APPENDIX B: SUBMISSIONS

**Western Coal Services Project (SSD 5579 MOD 1)
Response to Submissions**

**Western Coal Services Project (SSD 5579 MOD 1)
Comment on the Statement of Environmental Effects**

**WESTERN COAL SERVICES PROJECT - STATE SIGNIFICANT DEVELOPMENT SSD
5579, MODIFICATION 1, CASTLEREAGH HIGHWAY, LIDSDALE**

Figure 1 - Revised Cooks Dam/Wangcol Creek hydrological model to include significant cumulative impacts of leachate from various waste heaps on project site groundwater.

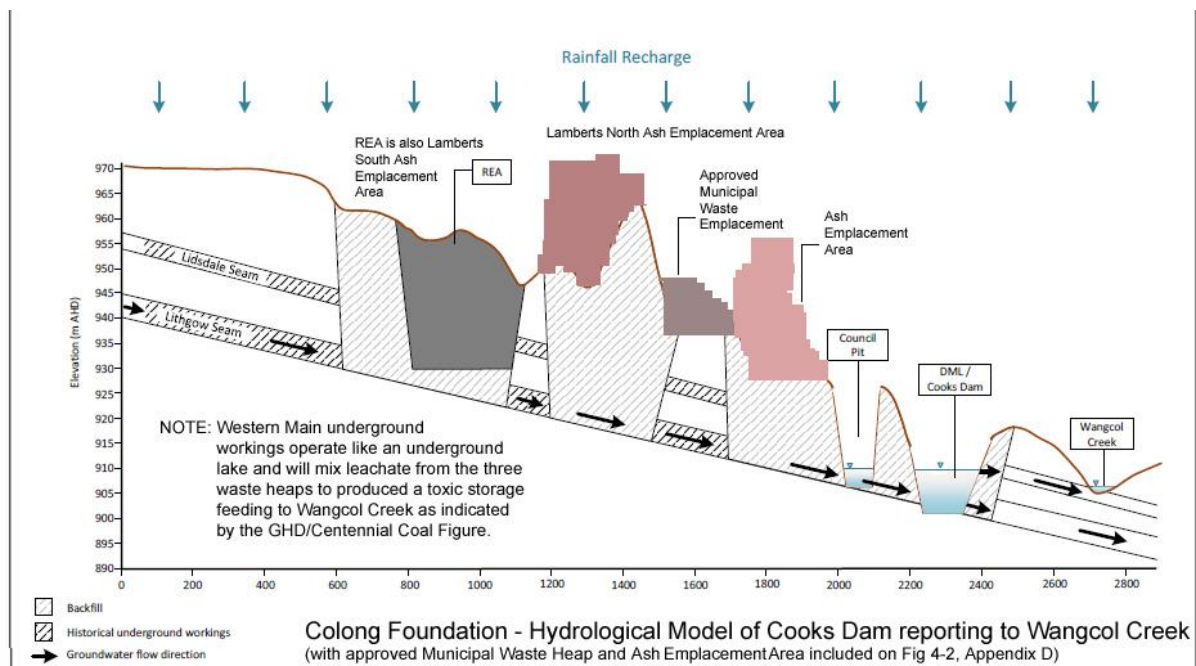
The Department of Planning and Environment must require the water and salinity load modelling to be redone with the cumulative impacts within the project area to be fully accounted for, as the likely consequences of these impacts are likely to greatly magnify the already large salinity problem associated with LDP006. Salinity levels at Cooks Dam discharge, LDP006, already approaches 5,000µS/cm.

The modelling analysis for the proposed minor works modification combines the beneficial outcomes from the treatment and power plant reuse of Springvale mine water from LPT009 with the adverse saline discharge from LTP006, to predict favourable cumulative downstream flows and salinity outcomes. While the cumulative assessment for this modification proposal is done for the downstream environment, the cumulative water input flows and salinity assessment is not done *for* the project area. This selective cumulative modelling assessment of the proposed modification creates an unreasonably favourable outcome that cannot eventuate as saline inputs from the ash and REA waste emplacements are omitted from the model.

The modelling assessment admits that mine water from old underground mine workings will find its way to LPT006 through Cooks Dam to Wangcol Creek (see *Figure 3 modelling schematic*) but ignores the large non-point groundwater discharges from the project area (see *additional Figure A* at the end of this submission).

Figure 2 shows extent of shallow old mine workings and open cut mines that make the project area porous and ensures that groundwater controls the water balance of the project area.

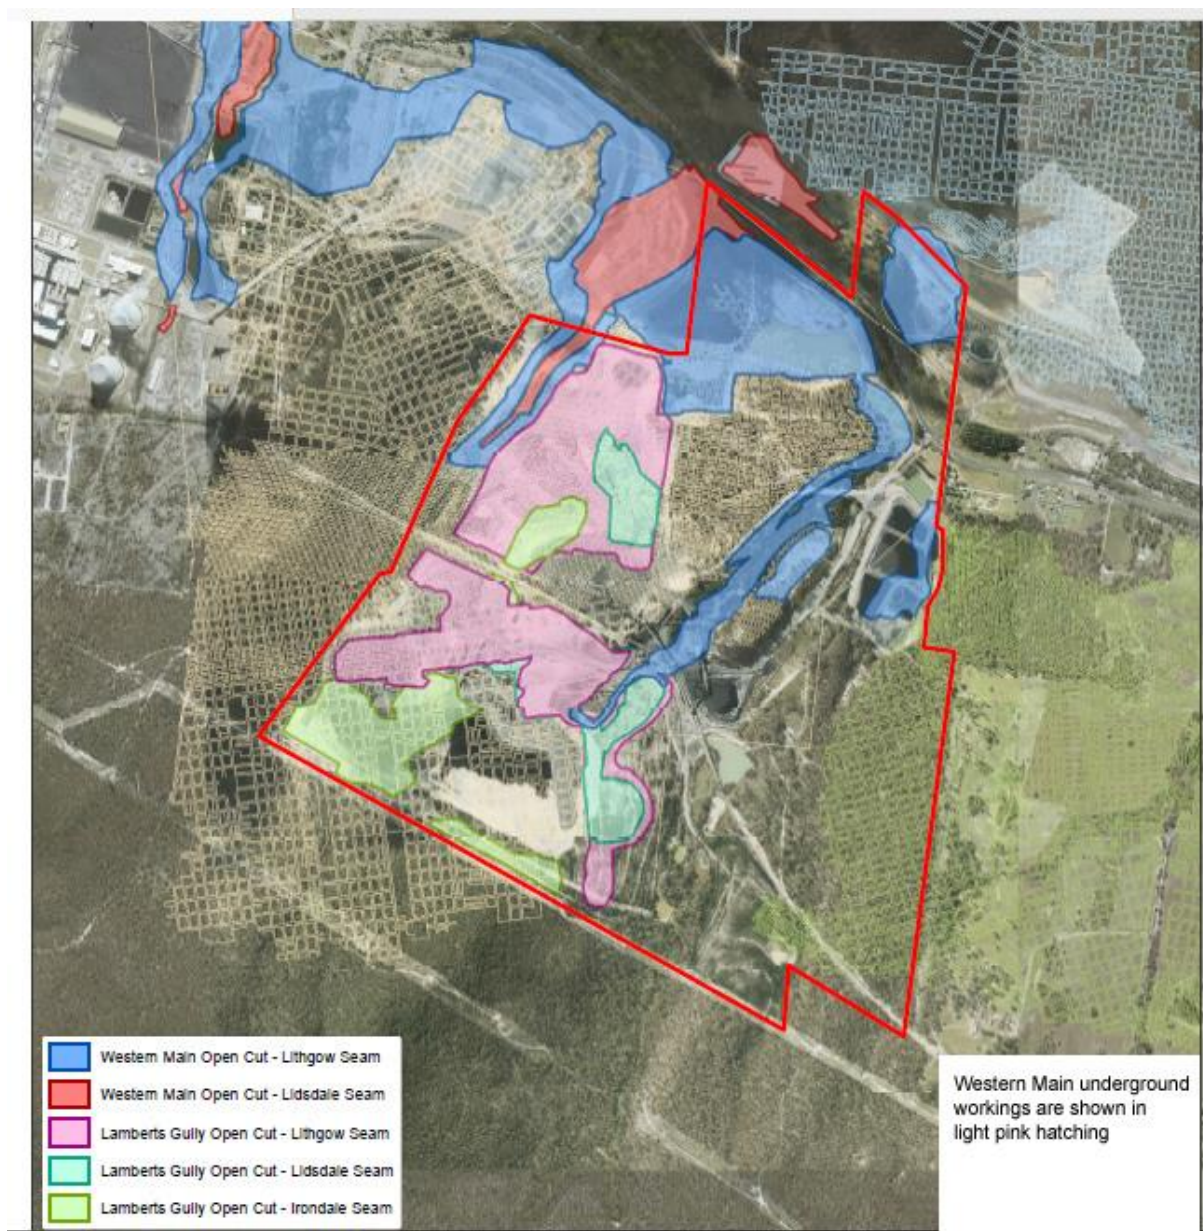
Groundwater is interconnected through the old bord and pillar workings of the Western Main mine, (see *figure 2*). The “clean” groundwater may “float” on top of the denser more saline groundwater within the mine workings. Such saline groundwater behaviour has implications for monitoring and management if it commences to report to Wangcol Creek in considerable volume.

Figure 3 The water transfer schematic does not explain that the 'Groundwater Environment' receives large inputs from the extensive waste heaps in the project area, not just the REA but also the ash emplacement areas, and possibly metropolitan waste area.

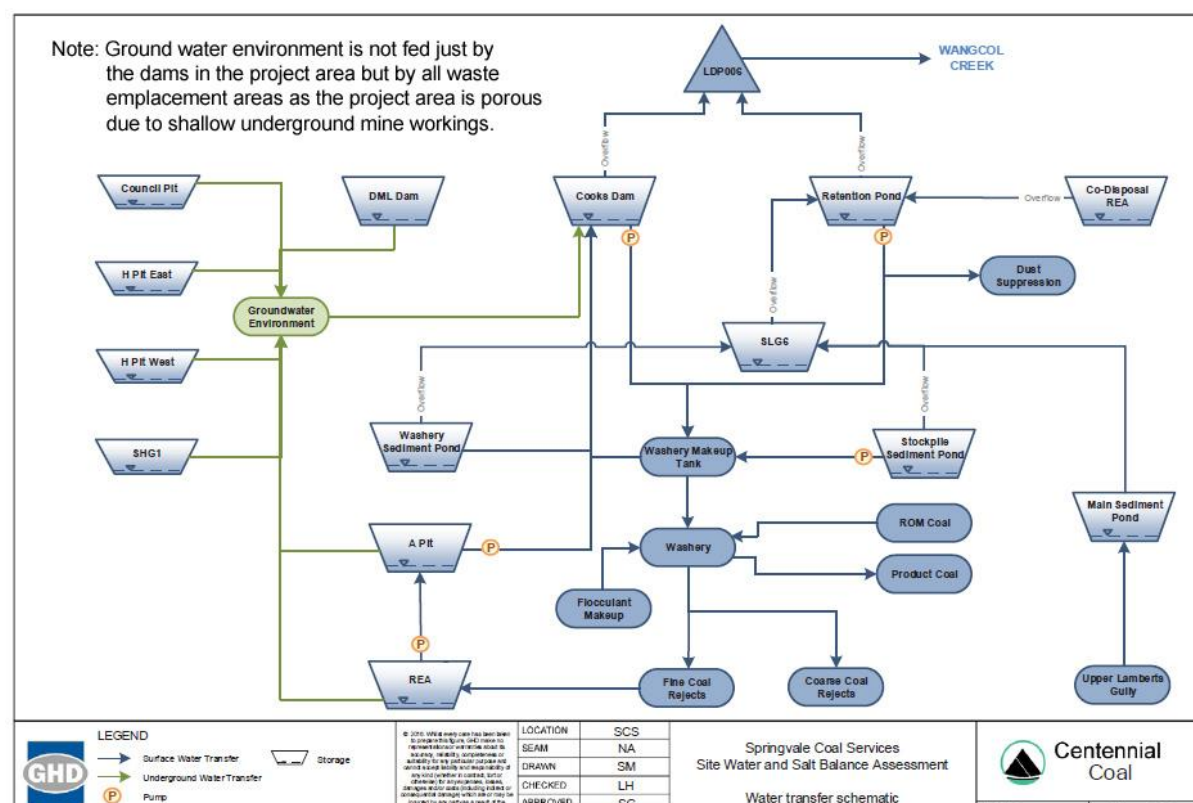
The lower part of the proposed “clean” catchment surrounds appears to be separated from the Co-disposal REA. This REA is described in the text on page 28 as having six cells. The two eastern cells are described as holding decant water, however *figure 3* shows decant water from these cells going to LDP006.

The regulation and treatment of contaminated groundwater within the project area is not investigated by the SEE. Ground water collection at Cooks Dam seems the most favourable option for its collection and subsequent treatment according to the schematic below (see *Figure 3*).

Additional Figure A – Saline groundwater – a growing non-point source of Wangcol Creek pollution.

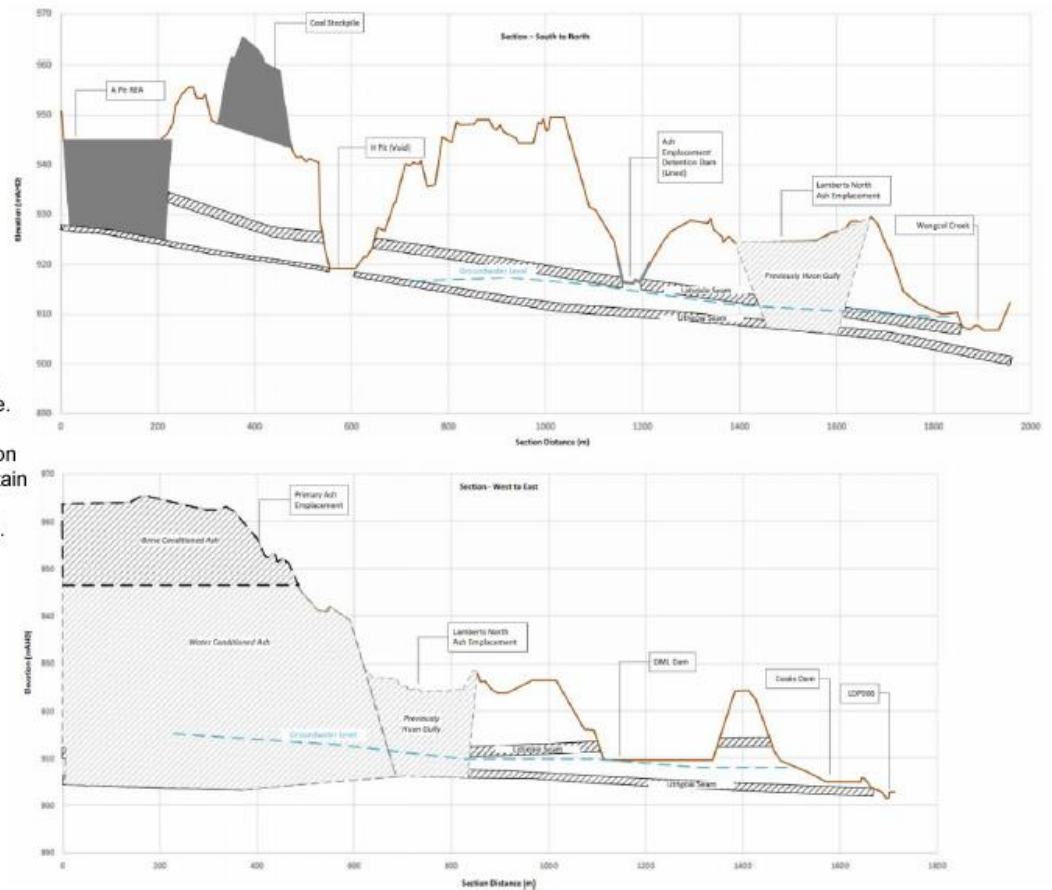
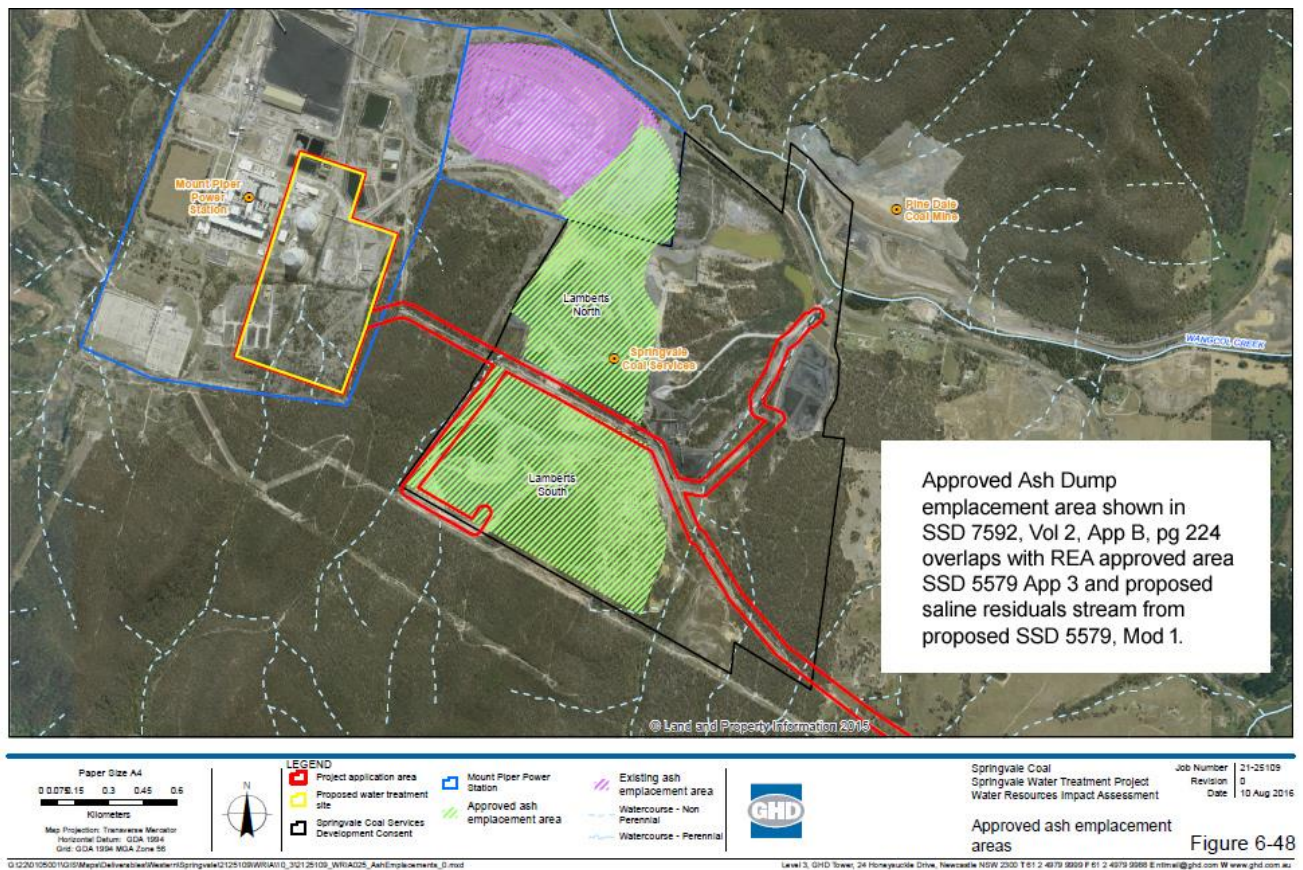
This ability of Cooks Dam to collect contaminated groundwater should be subject to further investigation. *Additional Figure A* indicates that Cooks Dam *does not* collect all saline groundwater.

Further, surface salinity monitoring data for Wangcol Creek demonstrates salinity increases from the Newbecks Creek junction to the Wangcol Creek gauge station to 585µS/cm (see Table 5-3, Vol 2, Appendix D of SEE) and again to the Wangcol Up Stream sampling site that read 2,577µS/cm, compared to LDP006 reading of 4,722µS/cm (Table 5-9, Vol 2, Appendix D of SEE, both sampled May

2016). These data when read with the groundwater cross section suggests that LDP006 does not collect all saline groundwater from the project site.

Non-point salinity pollution
of Wangcol Creek is certain
to increase unless
groundwater intercepted.

The project area groundwater must be further investigated to determine the proportion of saline groundwater that can be monitored and treated at LDP006. For example, it may be possible to control non-point groundwater discharges reporting to Wangcol Creek by a grout barrier or by management of storage levels in Cooks and DML dams at lower storage levels.

The consent should require further consideration of groundwater pollution with the view to improved containment and treatment.

Addition Figure C - shows size of SCSS site where co-disposal is proposed for saline residuals and large size of metropolitan waste emplacement area relative to it and the coal washery.

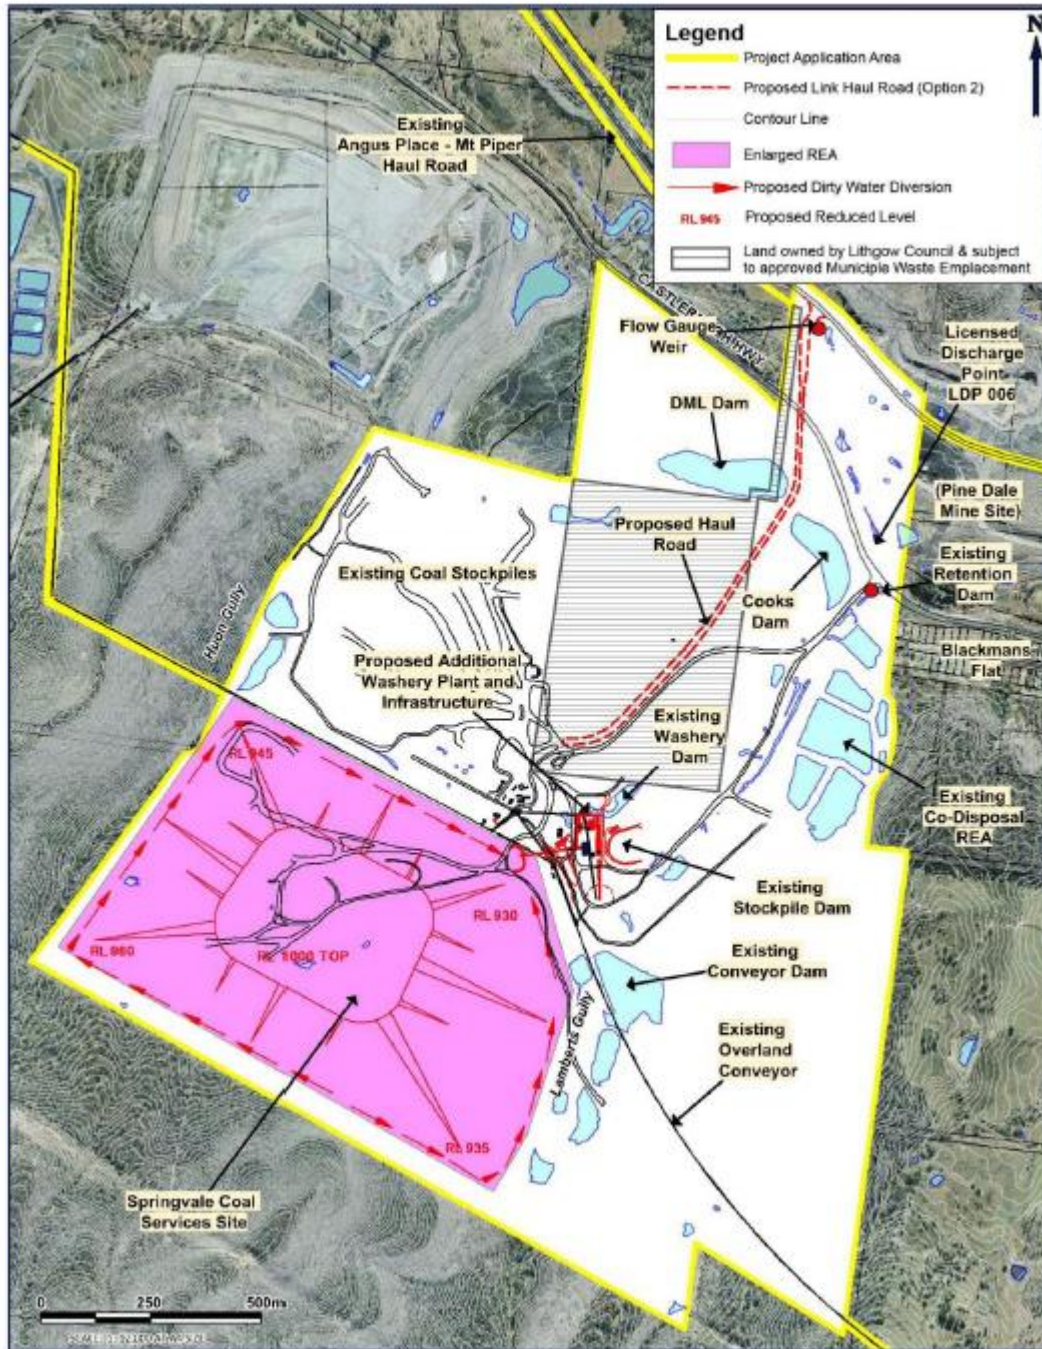
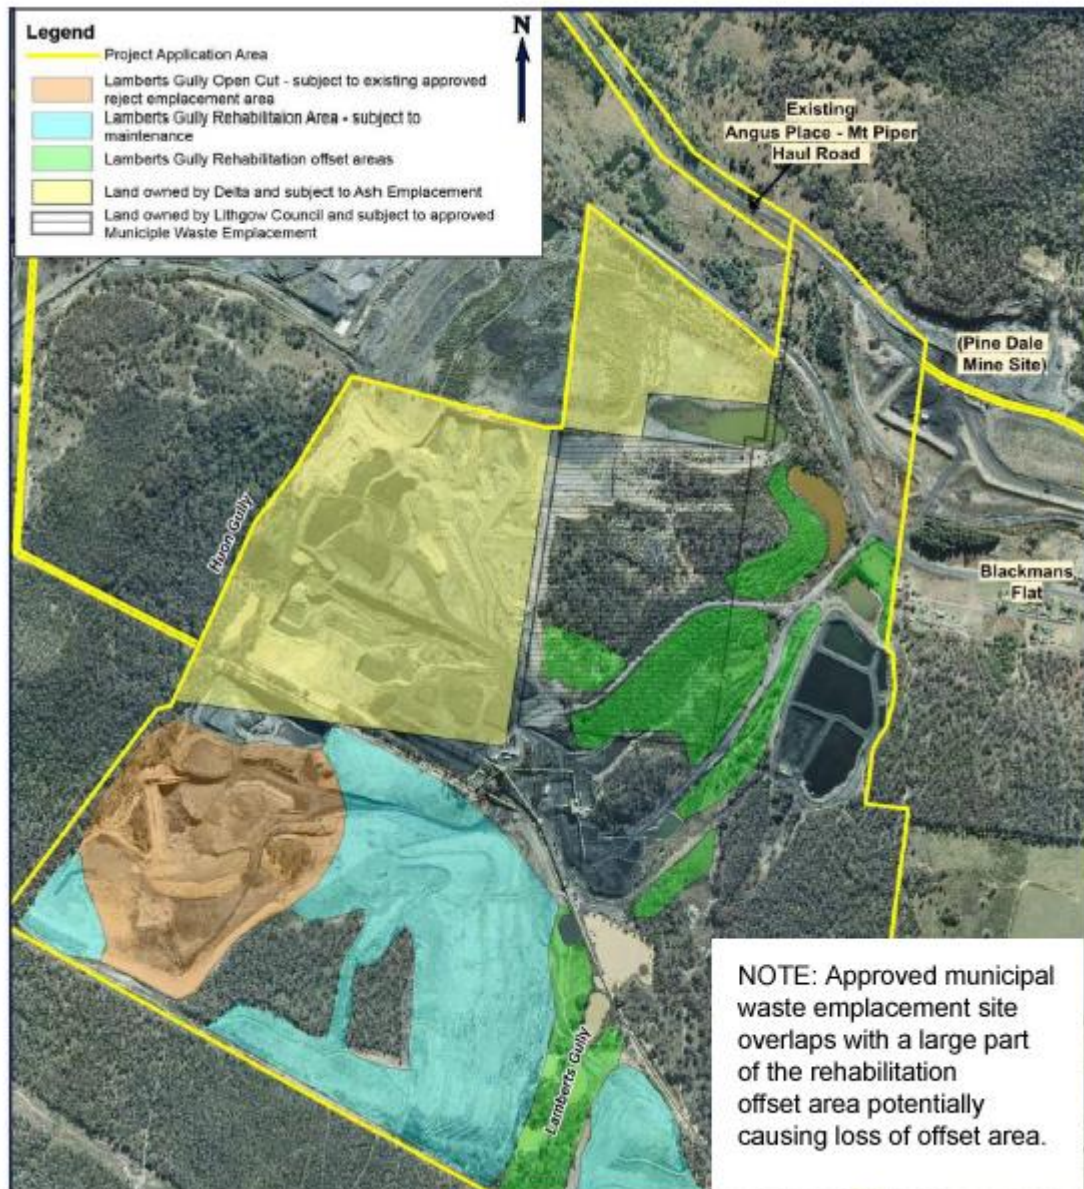
Municipal waste dump development also will replace a large part of the “Lamberts Gully Rehabilitation offset areas” (see *additional figure D*). Loss of this offset appears not to be accommodated by further offsets, and is a poor practise, as ecosystems can’t be traded as commodities without unexpected ecological outcomes.

Additional Figure B - shows approved brine modified ash emplacement overlaps – Lamberts South - with approved SCSS REA as shown in Addition Figure C below, which all overlap with the proposed residuals emplacement from the water treatment plant.

Additional figure D – a rehabilitation offset is to be replaced by a large municipal waste heap.
